Lamb Laneway House and Secondary Suite | 80 Lamb Ave, Toronto, Ontario | North Arrow Limited | Framing package

ISSUED FOR BUDGET AND COORDINATION, REV T4, 23 OCT 2026

Hanger Schedule – T 1.06B

2ND FLOOR DECK: BEAMS AND HANGERS (batch 2 and the balcony)

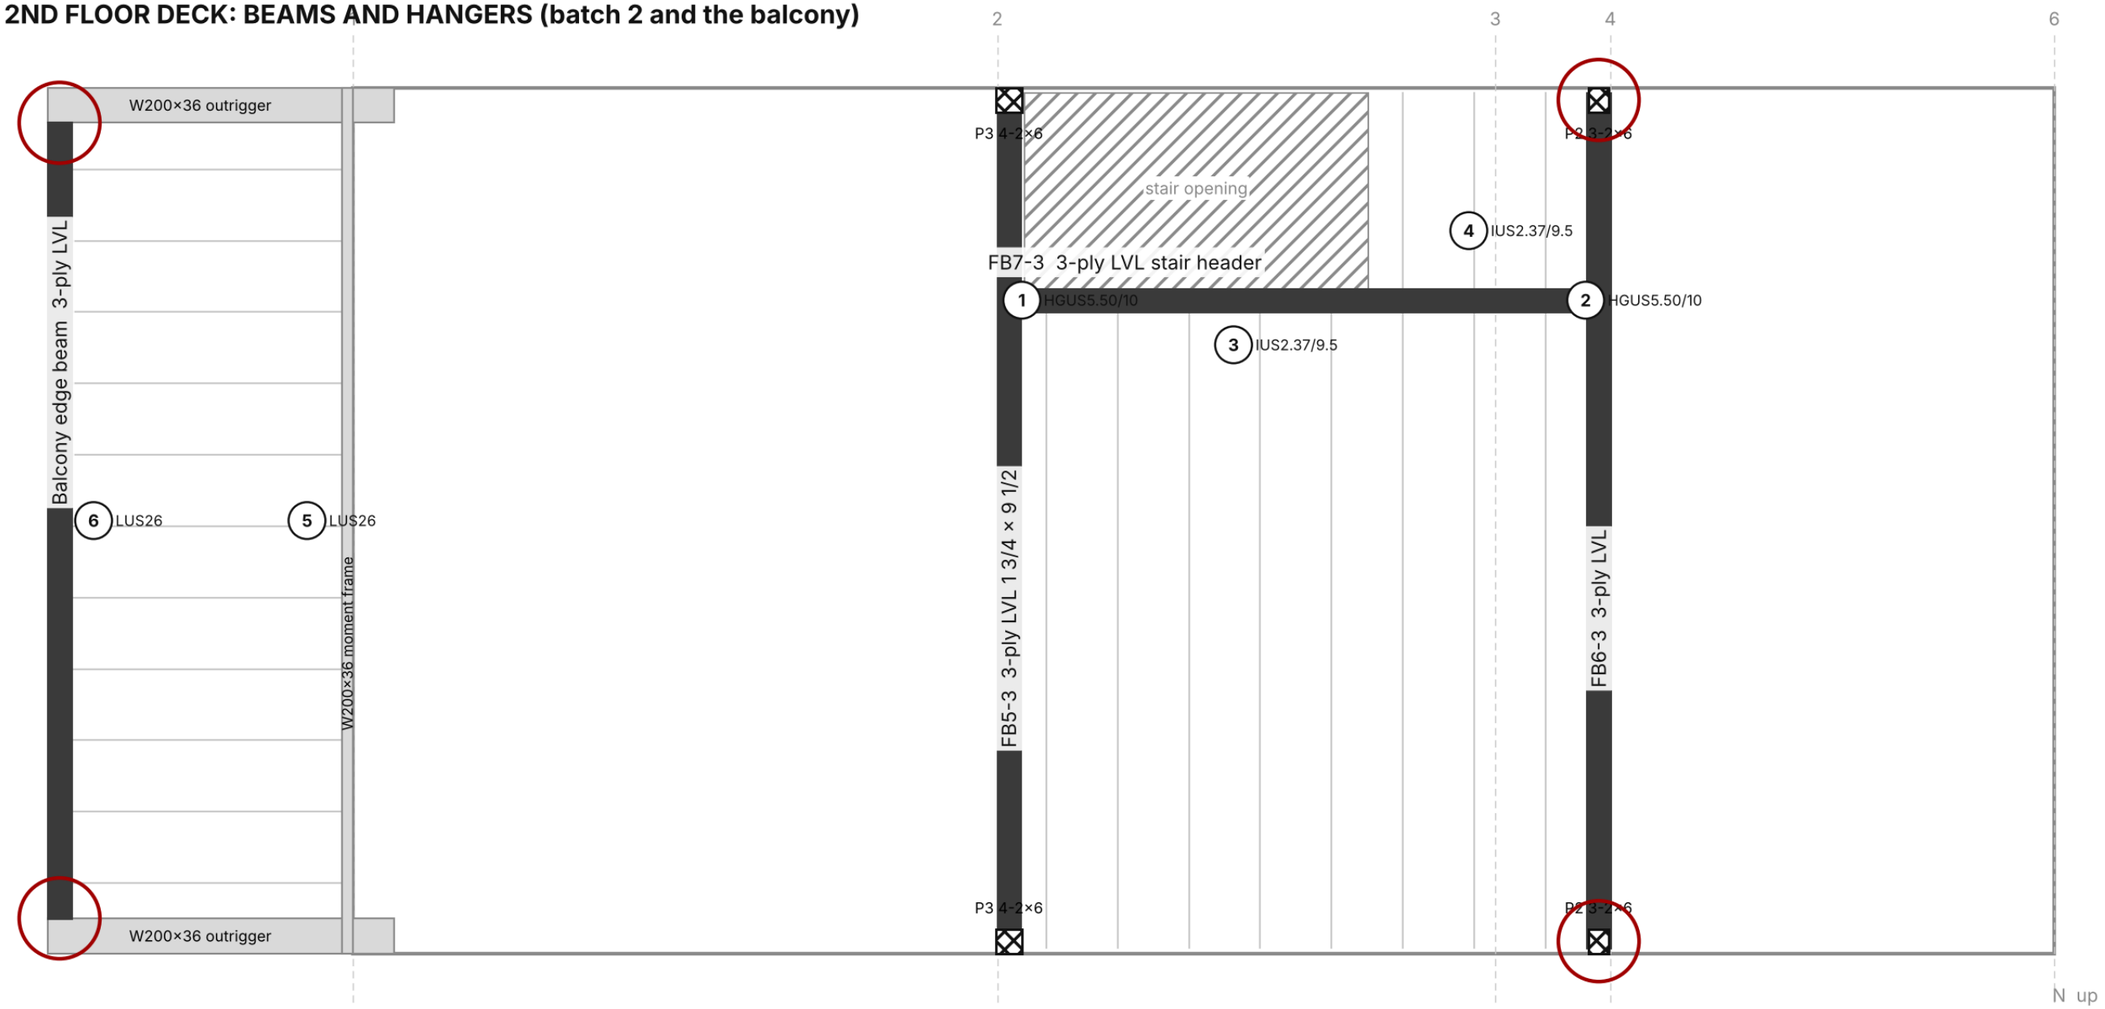
#	WHERE	MEMBER HUNG	END	HANGS ON	QTY	HANGER (T4)	T2 HAD	NOTES
1	2nd floor, stair opening	stair header, 3-ply LVL between the trimmers (Taiga FB7-3) (3-ply LVL 1 3/4 x 9 1/2)	west end	west stair trimmer, 3-ply LVL beam line at grid 2 (Taiga FB5-3)	1	**HGUS5.50/10**	HGUS5.50/10	
2	2nd floor, stair opening	stair header, 3-ply LVL between the trimmers (Taiga FB7-3) (3-ply LVL 1 3/4 x 9 1/2)	east end	east stair trimmer, 3-ply LVL beam line at grid 4 (Taiga FB6-3)	1	**HGUS5.50/10**	HGUS5.50/10	
3	2nd floor, stair opening	TJI tails south of the header, TJI 360 9 1/2"	north end	stair header, 3-ply LVL between the trimmers (Taiga FB7-3)	8	**IUS2.37/9.5**	IUS2.56/9.5	**CHANGED. TJI 360 has a 2 5/16" flange; IUS2.56 is for 2 1/2".**
4	2nd floor, stair opening	TJI east of the opening, north of the header, TJI 360 9 1/2"	south end	stair header, 3-ply LVL between the trimmers (Taiga FB7-3)	3	**IUS2.37/9.5**	IUS2.56/9.5	**CHANGED. TJI 360 has a 2 5/16" flange; IUS2.56 is for 2 1/2".**

5	Balcony deck	Balcony joists, 2x6	east end	House-side rim (2x6)	11	**LUS26**	LUS26 (13 per side typed)	**CHANGED. 11 joists in the model; T2 typed 13 a side.**
6	Balcony deck	Balcony joists, 2x6	west end	Balcony LVL edge beam (LVL 1 3/4 x 9 1/2)	11	**LUS26**	LUS26 (13 per side typed)	**CHANGED. 11 joists in the model; T2 typed 13 a side.**

ROOF AND LOWER LEVEL EAST OF GRID 2: BEAMS AND HANGERS (batch 4)

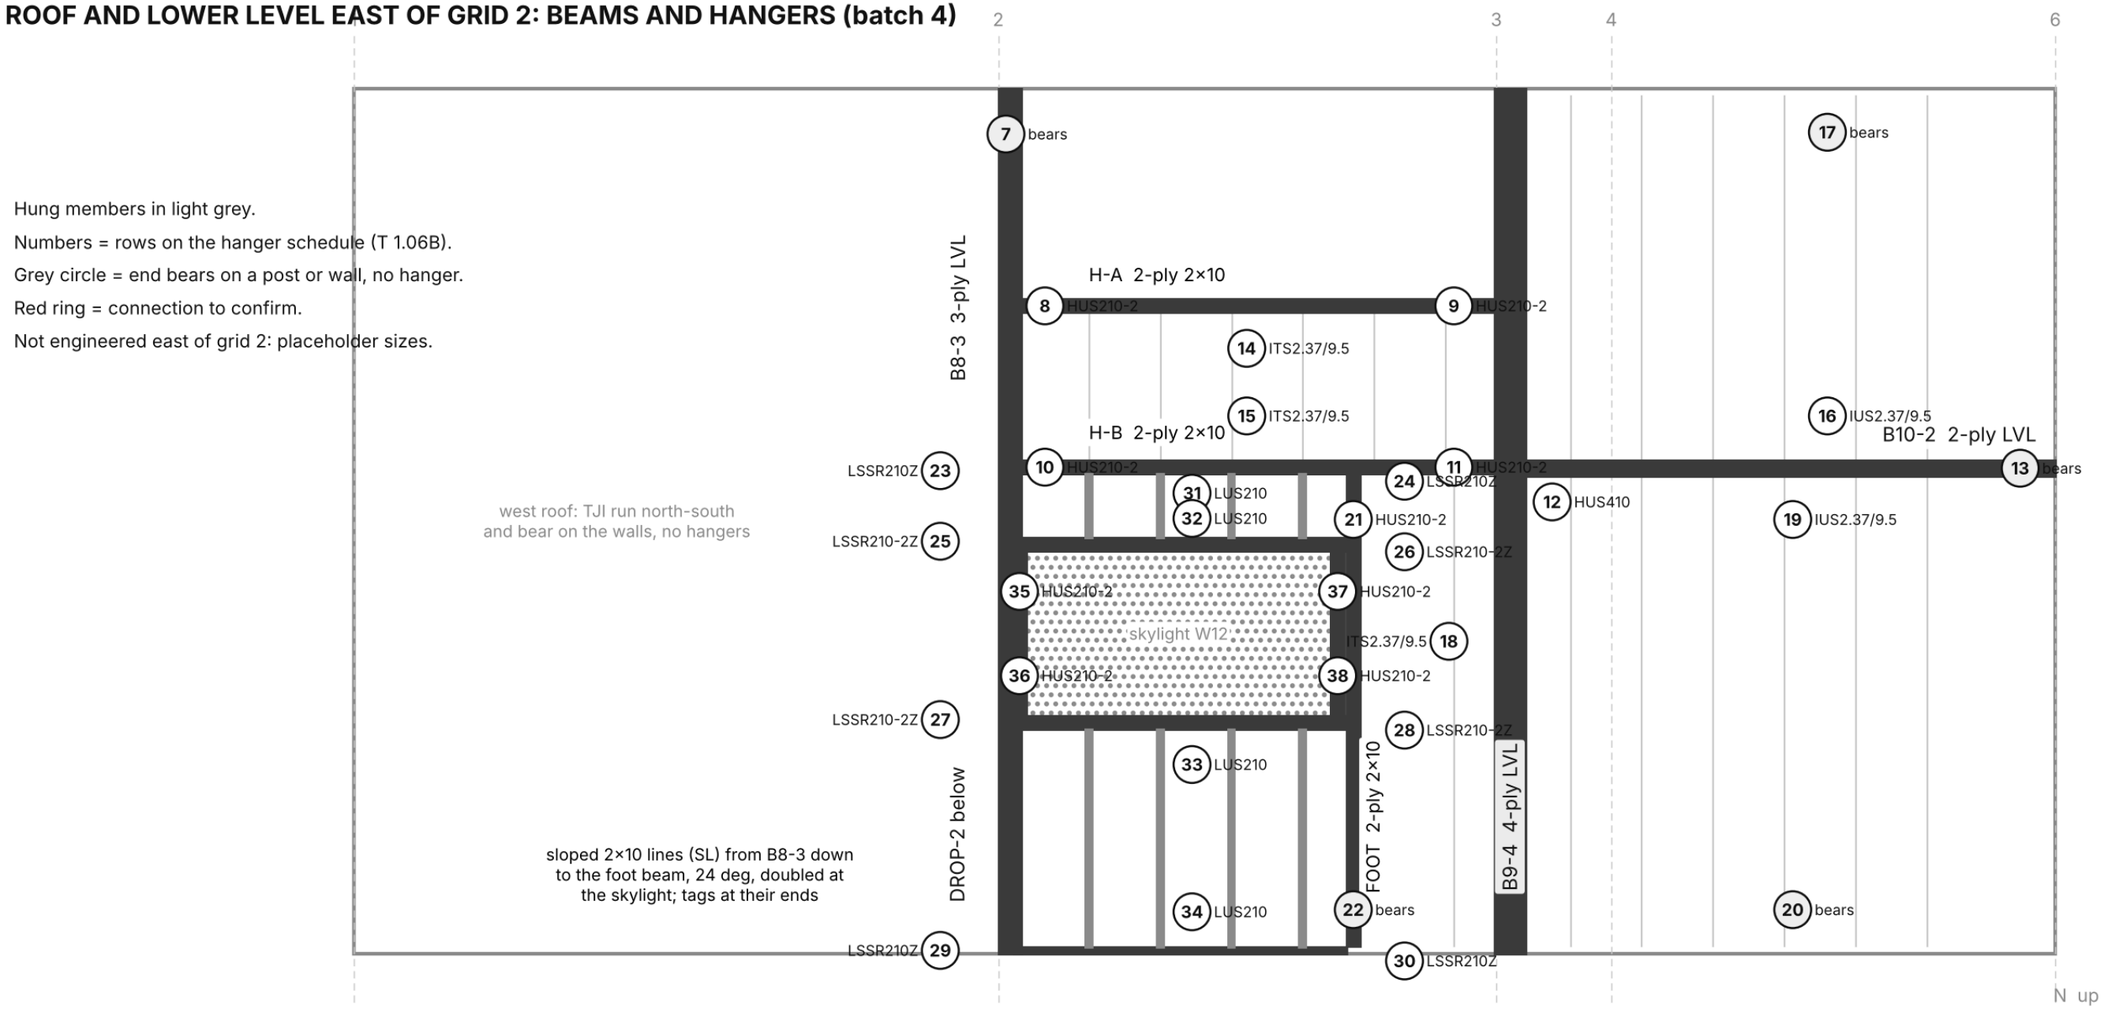
#	WHERE	MEMBER HUNG	END	HANGS ON	QTY	HANGER (T4)	T2 HAD	NOTES
7	Lower level east of grid 2	2-ply 2x10 drop beam on grid 2 under the lower level (2-ply 2x10)	both ends	P3 posts in the north and south walls	2	**none, bears**	HUS210-2	**CHANGED. Bears on the posts; post cap or seat to the engineer. T2 had two HUS210-2 hangers here.**
8	Lower level east of grid 2	2-ply 2x10 header at the south edge of the roof-stair opening, grid 2 to 3 (2-ply 2x10)	west end	2-ply 2x10 drop beam on grid 2 under the lower level	1	**HUS210-2**	HUS210-2	Not engineered yet.
9	Lower level east of grid 2	2-ply 2x10 header at the south edge of the roof-stair opening, grid 2 to 3 (2-ply 2x10)	east end	4-ply LVL beam at grid 3 (Taiga B9-4)	1	**HUS210-2**	HUS210-2	Not engineered yet.
10	Lower level east of grid 2	2-ply 2x10 header under the enclosure south wall, grid 2 to 3 (2-ply 2x10)	west end	2-ply 2x10 drop beam on grid 2 under the lower level	1	**HUS210-2**	HUS210-2	Not engineered yet.

11	Lower level east of grid 2	2-ply 2x10 header under the enclosure south wall, grid 2 to 3 (2-ply 2x10)	east end	4-ply LVL beam at grid 3 (Taiga B9-4)	1	**HUS210-2**	HUS210-2	Not engineered yet.
12	Lower level east of grid 2	2-ply LVL beam under the enclosure south wall, grid 3 to the east wall (Taiga B10-2) (2-ply LVL 1 3/4 x 9 1/2)	west end	4-ply LVL beam at grid 3 (Taiga B9-4)	1	**HUS410**	HUS410	
13	Lower level east of grid 2	2-ply LVL beam under the enclosure south wall, grid 3 to the east wall (Taiga B10-2) (2-ply LVL 1 3/4 x 9 1/2)	east end	east wall	1	**none, bears**	HUS410	**CHANGED. T2 carried a second HUS410 here.**
14	Enclosure floor, grid 2 to 3	Enclosure floor joists, TJI 360 9 1/2"	north end	2-ply 2x10 header at the south edge of the roof-stair opening, grid 2 to 3	6	**ITS2.37/9.5**	IUS2.56/9.5	**CHANGED. Not engineered yet. TJI 360 has a 2 5/16" flange; IUS2.56 is for 2 1/2". Header is 1/4" shallower than the TJI, so top flange.**

15	Enclosure floor, grid 2 to 3	Enclosure floor joists, TJI 360 9 1/2"	south end	2-ply 2x10 header under the enclosure south wall, grid 2 to 3	6	**ITS2.37/9.5**	IUS2.56/9.5	**CHANGED. Not engineered yet. TJI 360 has a 2 5/16" flange; IUS2.56 is for 2 1/2". Header is 1/4" shallower than the TJI, so top flange.**
16	Enclosure floor east of grid 3	Enclosure floor joists, TJI 360 9 1/2"	south end	2-ply LVL beam under the enclosure south wall, grid 3 to the east wall (Taiga B10-2)	6	**IUS2.37/9.5**	IUS2.56/9.5	**CHANGED. Not engineered yet. TJI 360 has a 2 5/16" flange; IUS2.56 is for 2 1/2".**
17	Enclosure floor east of grid 3	Enclosure floor joists, TJI 360 9 1/2"	north end	north wall plate	6	**none, bears**	IUS2.56/9.5	**CHANGED. T2 hung these ends too.**
18	East low roof	East roof joists west of grid 3, TJI 360 9 1/2"	north end	2-ply 2x10 header under the enclosure south wall, grid 2 to 3	1	**ITS2.37/9.5**	IUS2.56/9.5	**CHANGED. Not engineered yet. TJI 360 has a 2 5/16" flange; IUS2.56 is for 2 1/2". Header is 1/4" shallower than the TJI, so top flange.**

19	East low roof	East roof joists east of grid 3, TJI 360 9 1/2"	north end	2-ply LVL beam under the enclosure south wall, grid 3 to the east wall (Taiga B10-2)	6	**IUS2.37/9.5**	IUS2.56/9.5	**CHANGED. Not engineered yet. TJI 360 has a 2 5/16" flange; IUS2.56 is for 2 1/2".**
20	East low roof	East roof joists, TJI 360 9 1/2"	south end	south wall plate	7	**none, bears**	none	bears, no hanger
21	Sloped roof	2-ply 2x10 foot beam at the bottom of the slope (2-ply 2x10)	north end	2-ply 2x10 header under the enclosure south wall, grid 2 to 3	1	**HUS210-2**	HUS210-2	Not engineered yet.
22	Sloped roof	2-ply 2x10 foot beam at the bottom of the slope (2-ply 2x10)	south end	south wall plate	1	**none, bears**	none	bears, no hanger
23	Sloped roof	sloped 2x10, north edge of the slope (2x10, sloped 24 deg)	high end (SL-2158)	3-ply LVL roof beam at grid 2, high end of the slope (Taiga B8-3)	1	**LSSR210Z**	LSSU210	**CHANGED. Not engineered yet. LSSU210 is discontinued. The plumb cut at the slope is 10 1/8" deep against a 9 1/2" support: seat or bevel the bottom to suit, Hossein to confirm.**

24	Sloped roof	sloped 2x10, north edge of the slope (2x10, sloped 24 deg)	low end (SL-2158)	2-ply 2x10 foot beam at the bottom of the slope	1	**LSSR210Z**	LSSU210	**CHANGED. Not engineered yet. LSSU210 is discontinued. The plumb cut at the slope is 10 1/8" deep against a 9 1/4" support: seat or bevel the bottom to suit, Hossein to confirm.**
25	Sloped roof	sloped 2-ply 2x10, north trimmer of the skylight (2-ply 2x10, sloped 24 deg)	high end (SL-2560)	3-ply LVL roof beam at grid 2, high end of the slope (Taiga B8-3)	1	**LSSR210-2Z**	LSSU210 x2 (one per ply)	**CHANGED. Not engineered yet. LSSU210 is discontinued. One double hanger per end, not two singles. The plumb cut at the slope is 10 1/8" deep against a 9 1/2" support: seat or bevel the bottom to suit, Hossein to confirm.**
26	Sloped roof	sloped 2-ply 2x10, north trimmer of the skylight (2-ply 2x10, sloped 24 deg)	low end (SL-2560)	2-ply 2x10 foot beam at the bottom of the slope	1	**LSSR210-2Z**	LSSU210 x2 (one per ply)	**CHANGED. Not engineered yet. LSSU210 is discontinued. One double hanger per end, not two singles. The plumb cut at the slope is 10 1/8" deep against a 9 1/4" support: seat or bevel the bottom to suit, Hossein to confirm.**

27	Sloped roof	sloped 2-ply 2x10, south trimmer of the skylight (2-ply 2x10, sloped 24 deg)	high end (SL-3576)	3-ply LVL roof beam at grid 2, high end of the slope (Taiga B8-3)	1	**LSSR210-2Z**	LSSU210 x2 (one per ply)	**CHANGED. Not engineered yet. LSSU210 is discontinued. One double hanger per end, not two singles. The plumb cut at the slope is 10 1/8" deep against a 9 1/2" support: seat or bevel the bottom to suit, Hossein to confirm.**
